ACCESS REPORT

PROJECT: **Vincentia High School upgrade**
PROJECT NO: **GDL240274**
PREPARED FOR: **NSW Department of Education (DoE)**
REVISION: **G**
DATE: **26.03.2025**

This Access Consultant 100% Schematic Access Report has been prepared to support a Review of Environmental Factors (REF) for the NSW Department of Education (DoE) for Vincentia High School upgrade (the activity).

1 PLAN
EXTERNAL WORKS PLAN
SCALE: 1:200

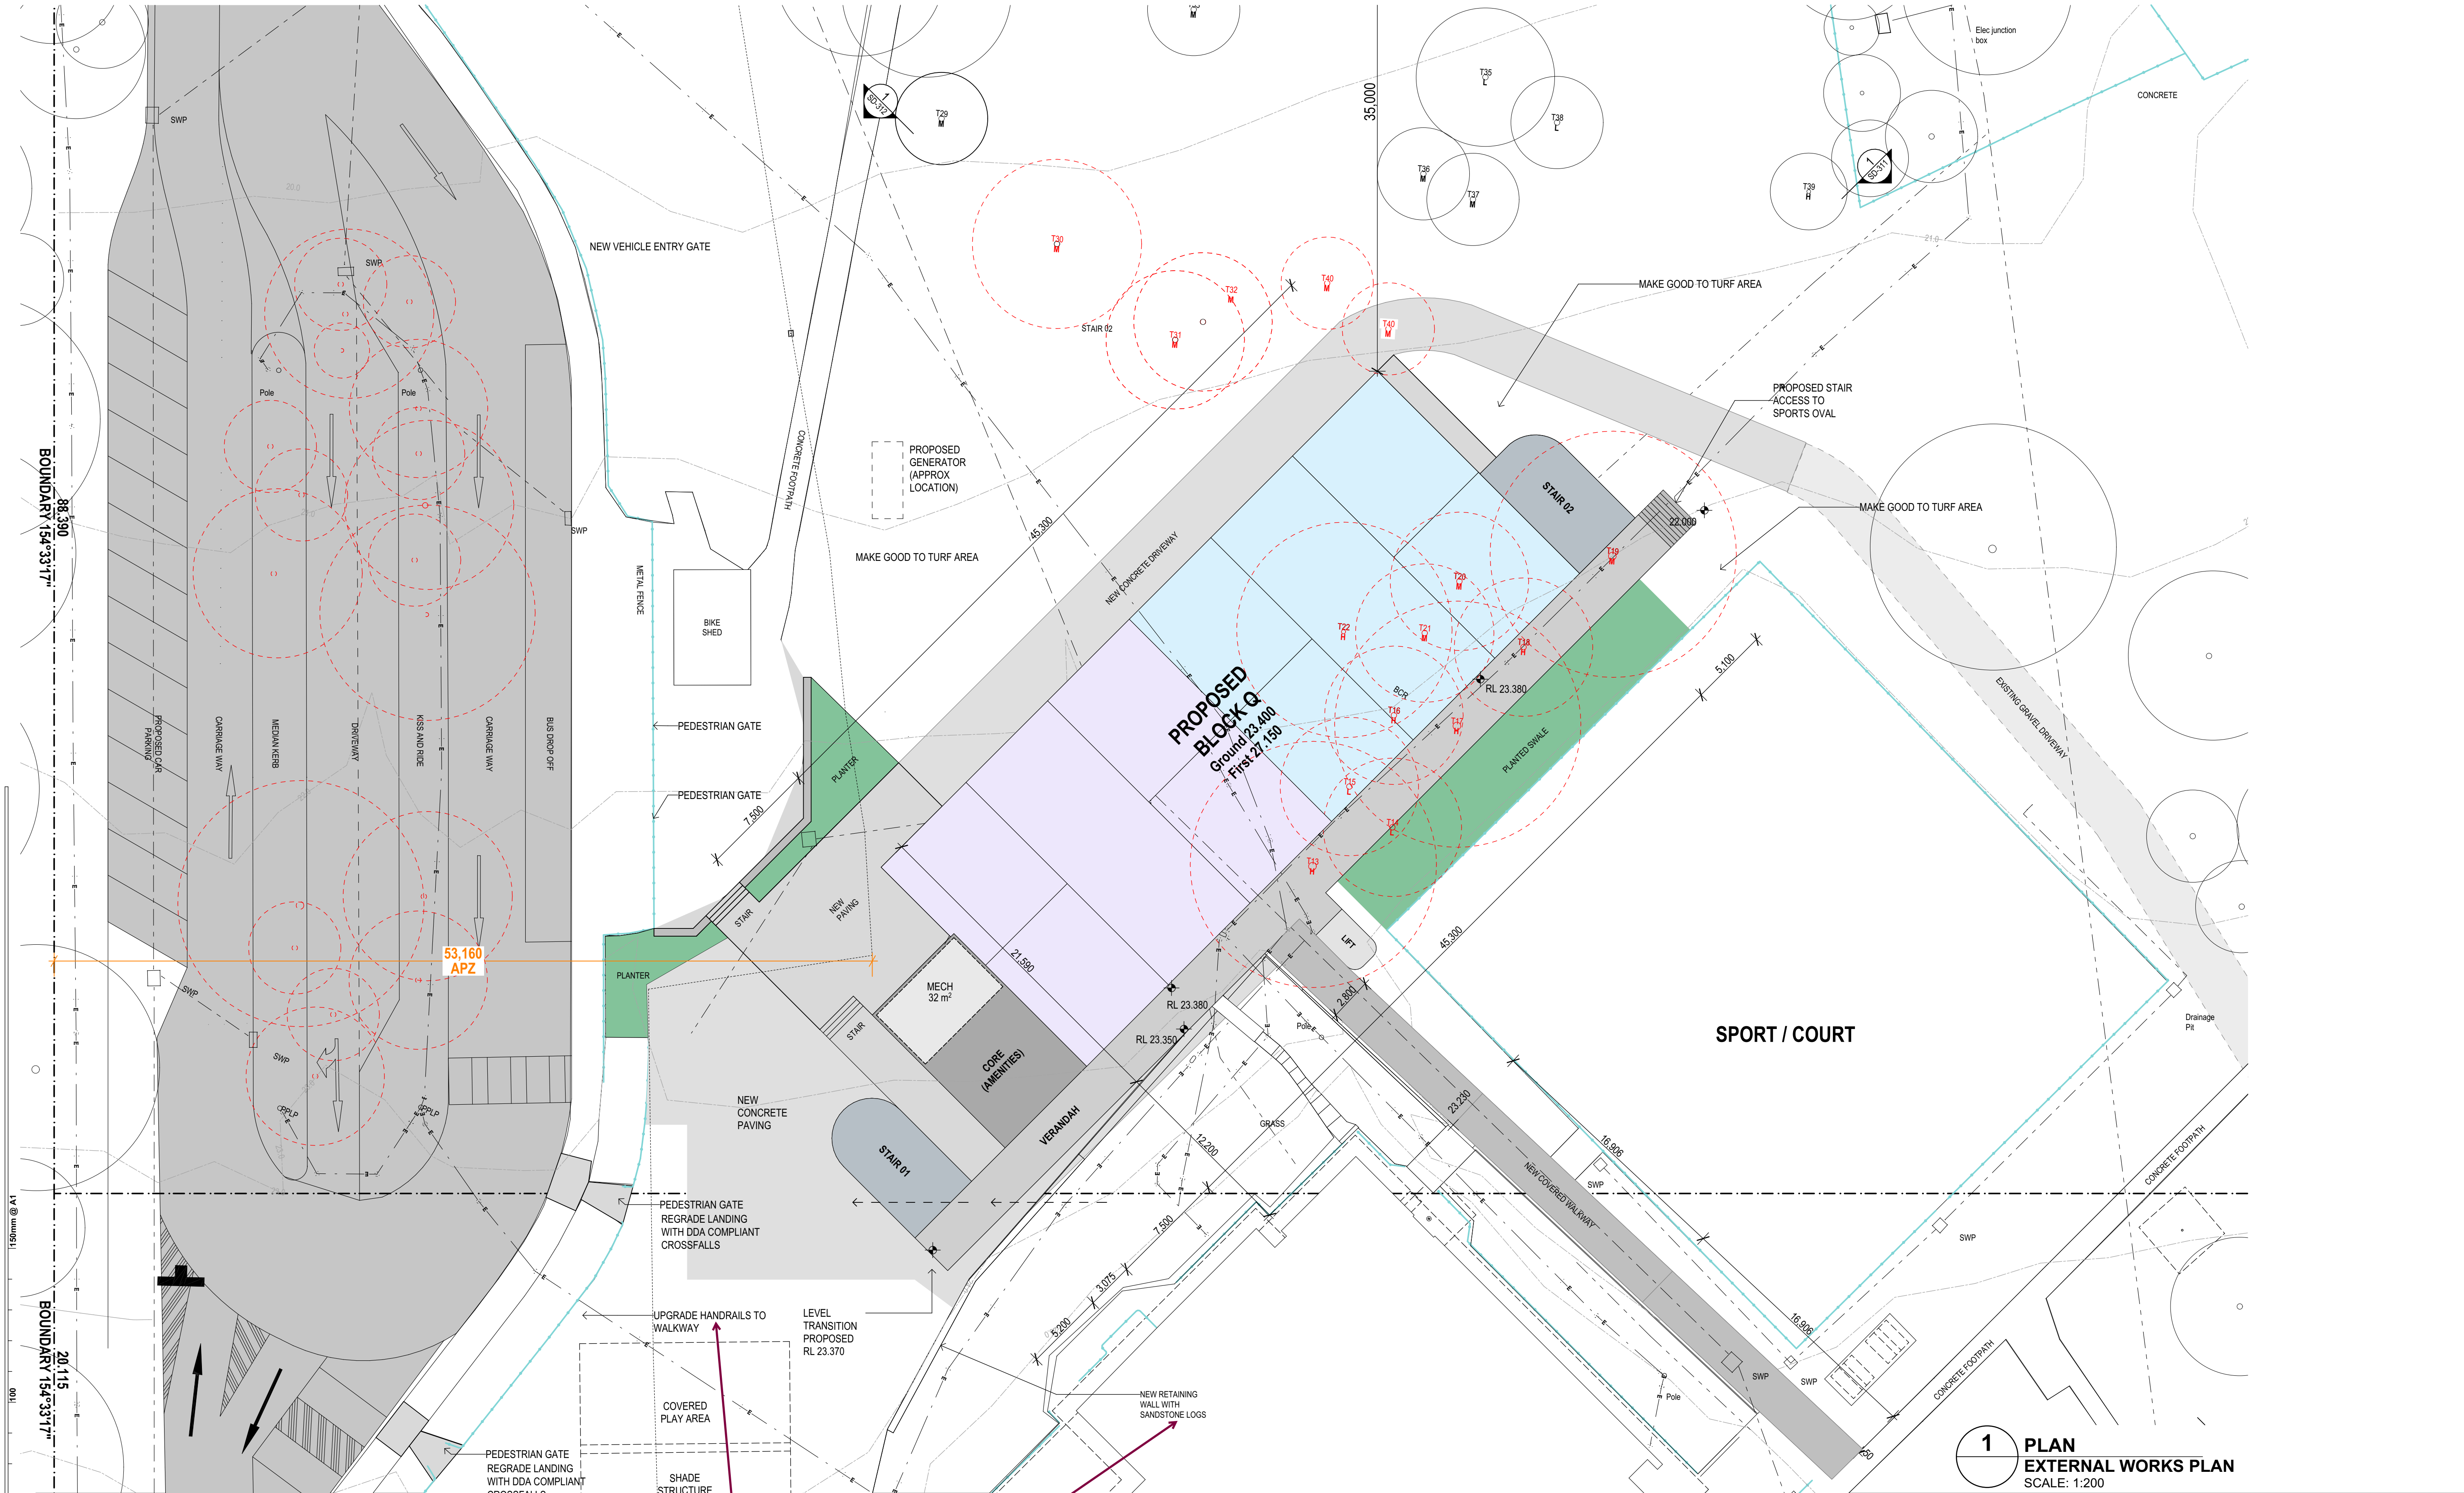
GDLA_DDA_6
Recommended that handrails on this walkway conform to AS1428.1 in their height, handrail profile and contrast to their surroundings for safety in design - DDA/Advisory

2 PLAN
STAGING PLAN - PHASE 2 (NEW BUILD)
SCALE: 1:1000

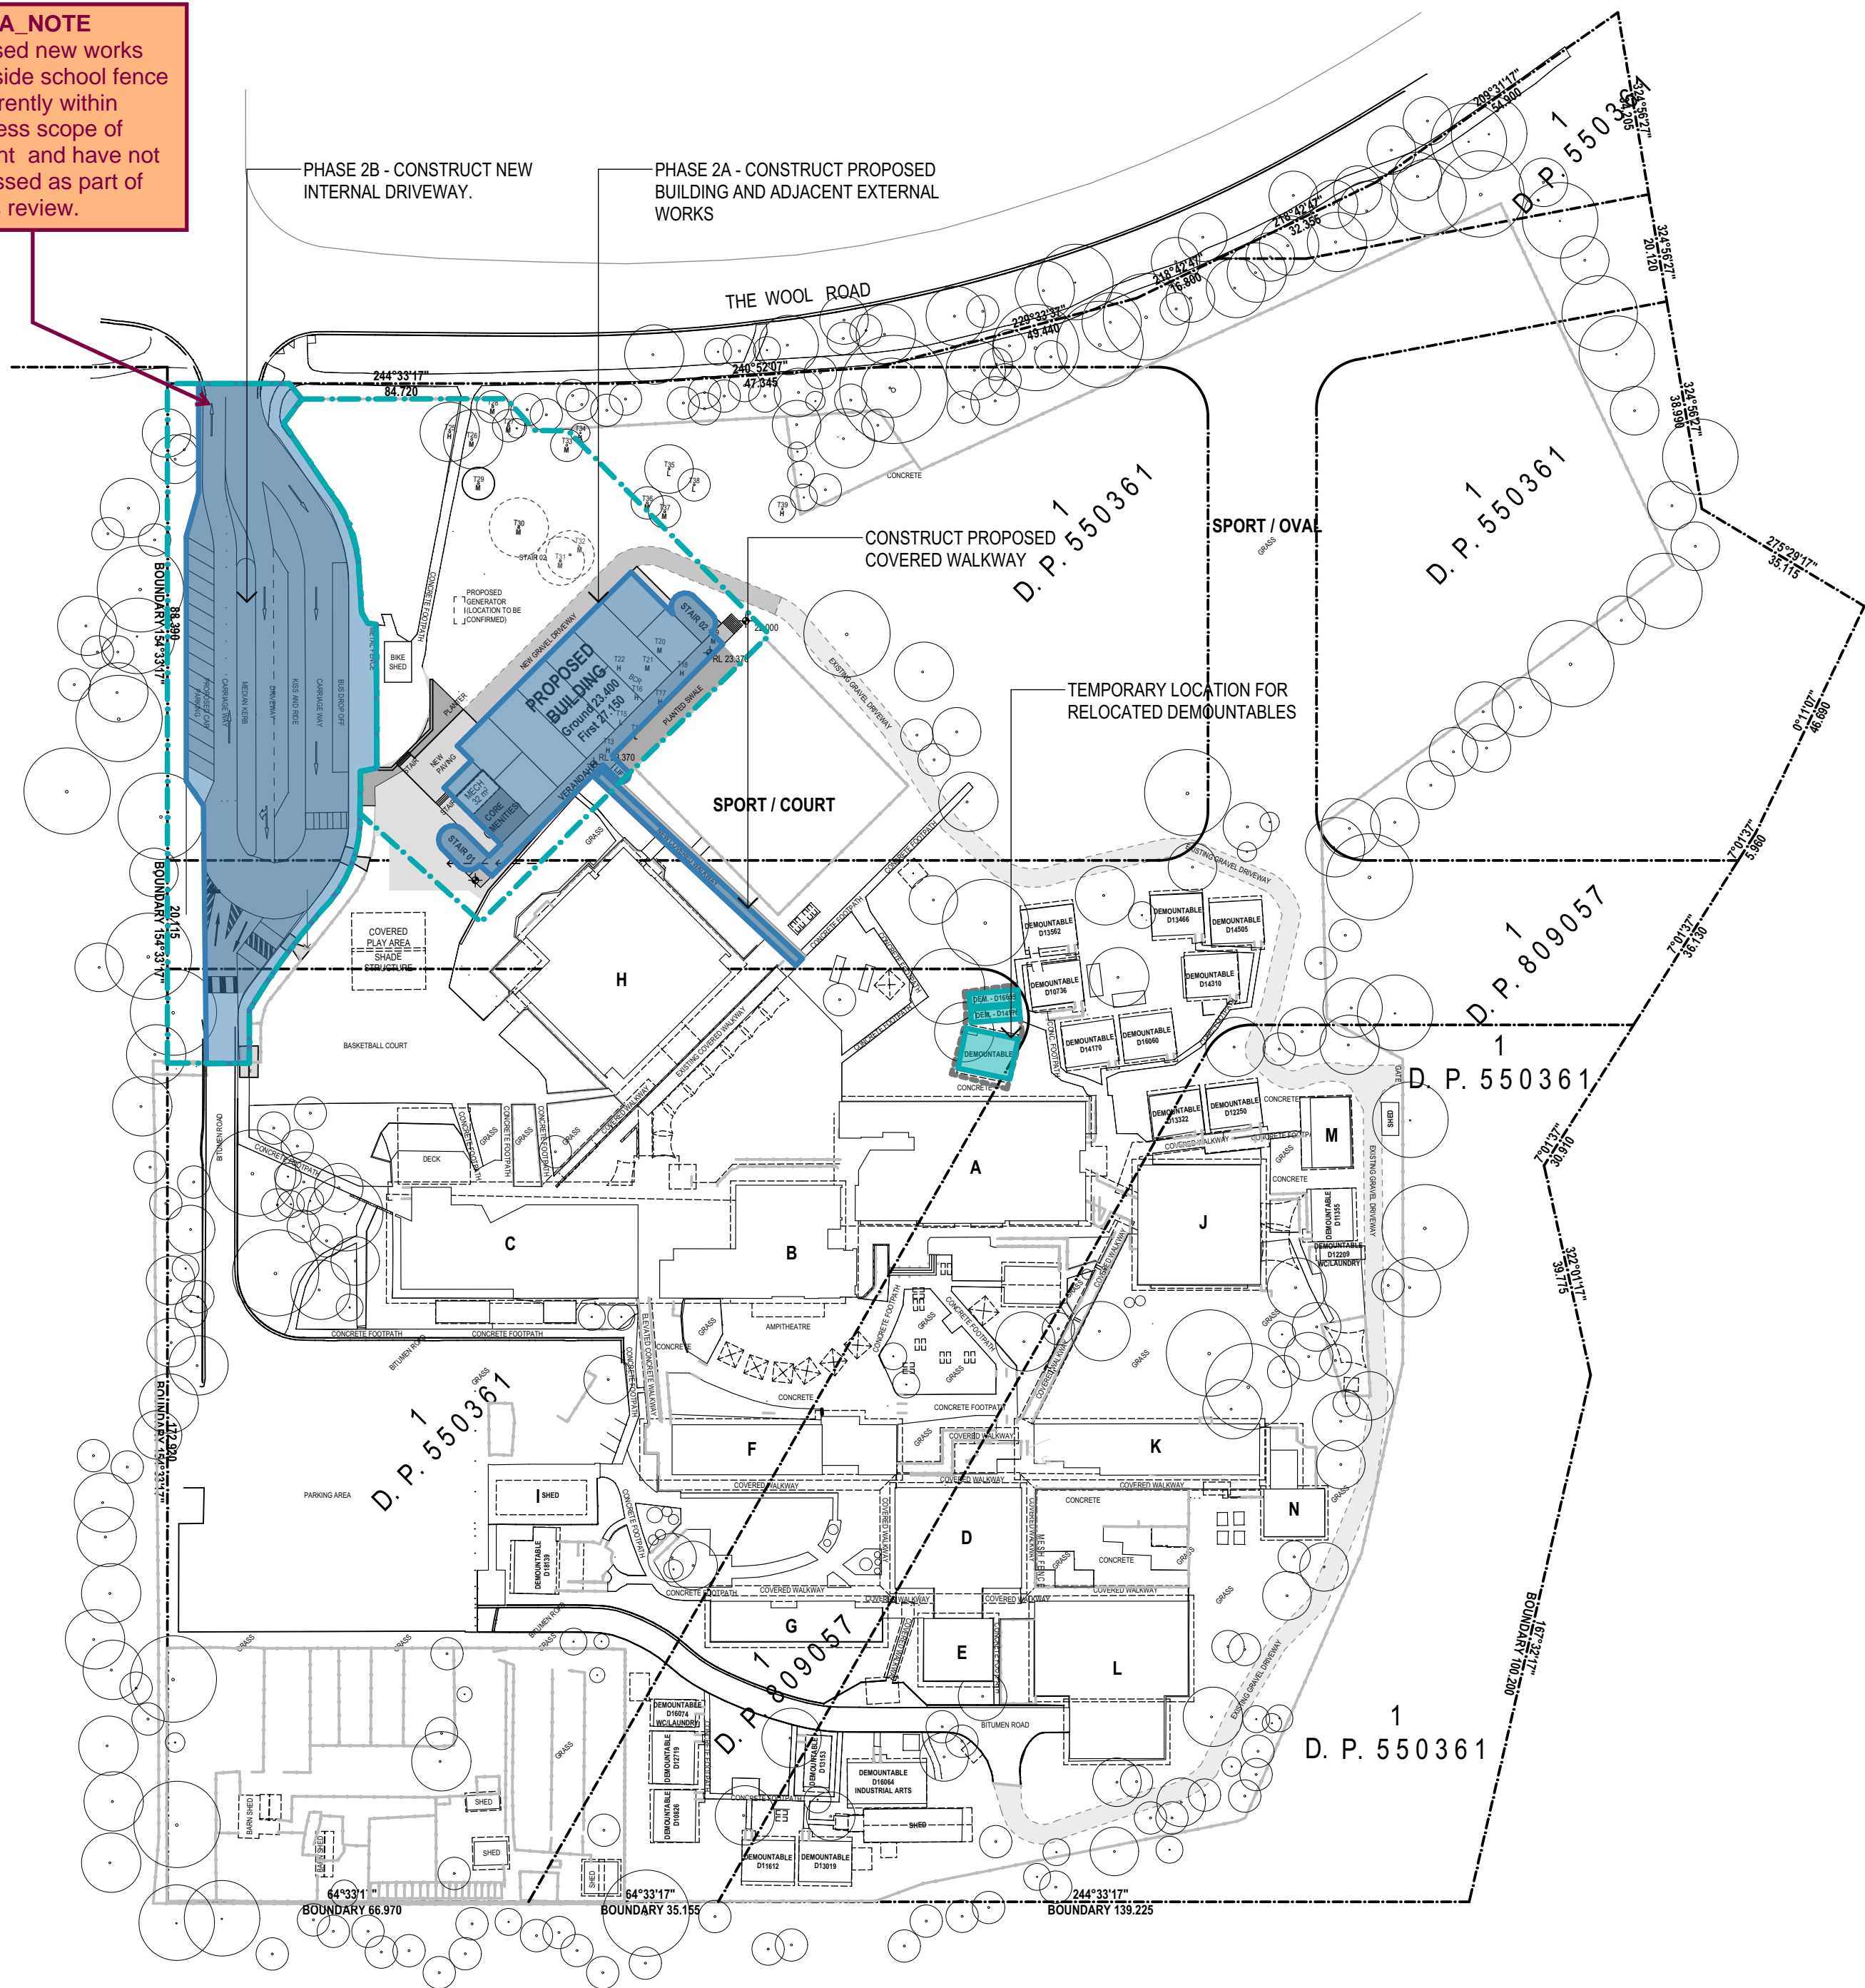
GDLA_DDA NOTE
The proposed new works shown outside school fence are not currently within GDLA Access scope of engagement and have not been assessed as part of this access review.

2 ELEVATION
EAST ELEVATION
SCALE: 1:100

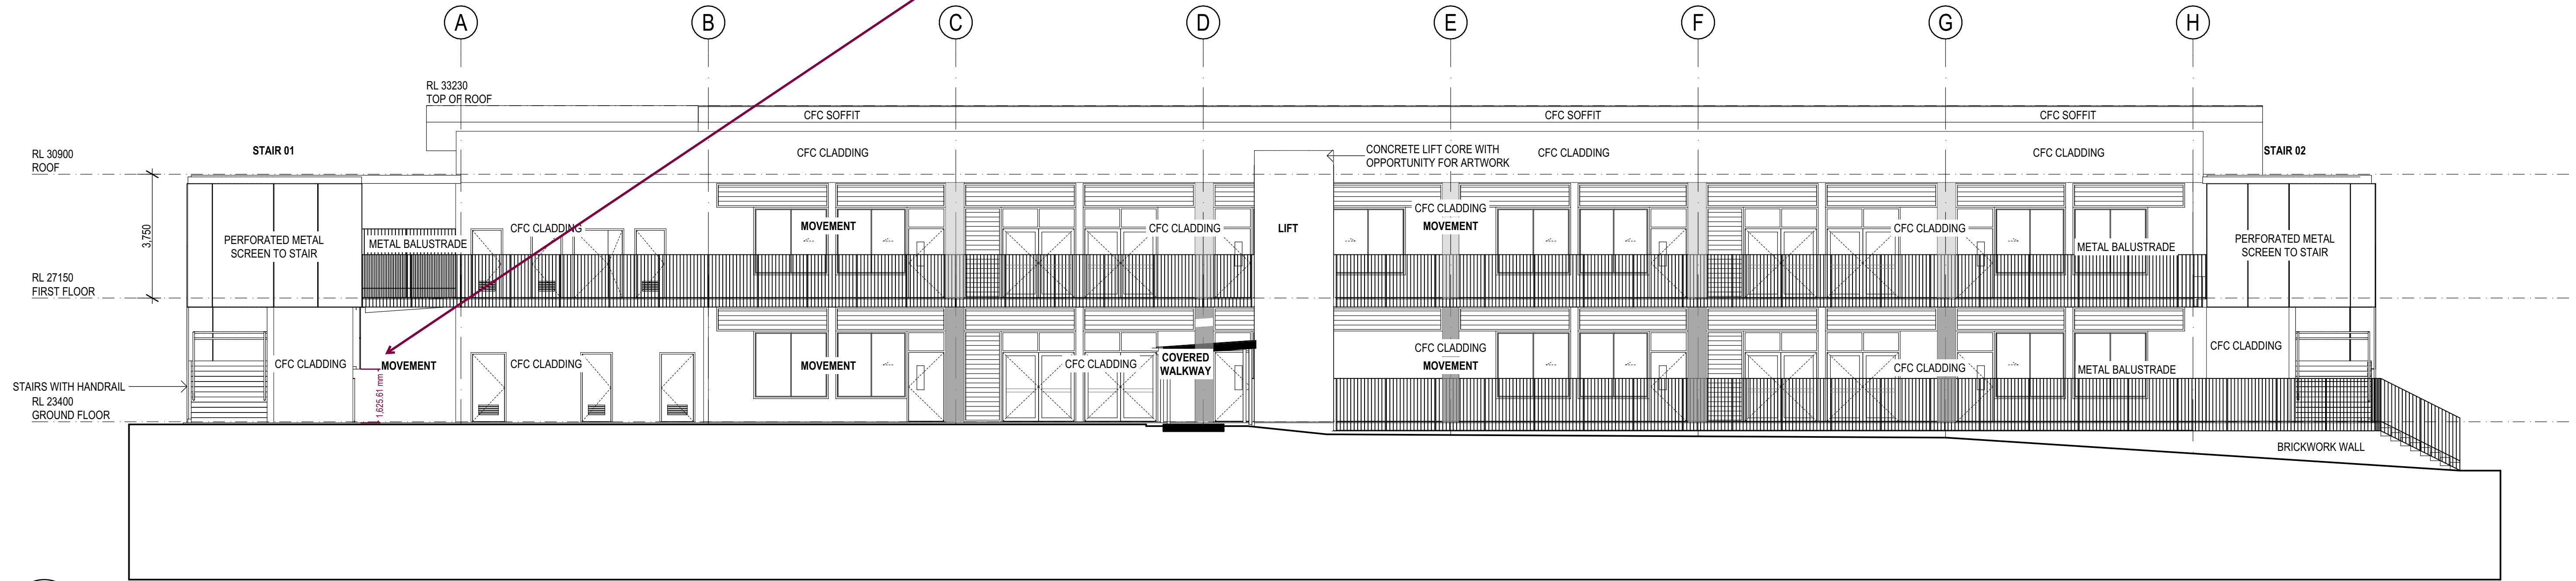
GDLA_DDA_15
Any understair areas that are accessible via the Movement areas and are less than 2M AFFL are to be suitable enclosed to prevent overhead collisions. This may be achieved by preventing access by the use of a handrail or by enclosing the space.
In addition, at a set of stairs it is permissible for an obstruction to be 600mm minimum above the top edge of the handrail.
Detail of this overhang in relation to the required handrail clearances and overhead clearances is to be reviewed.
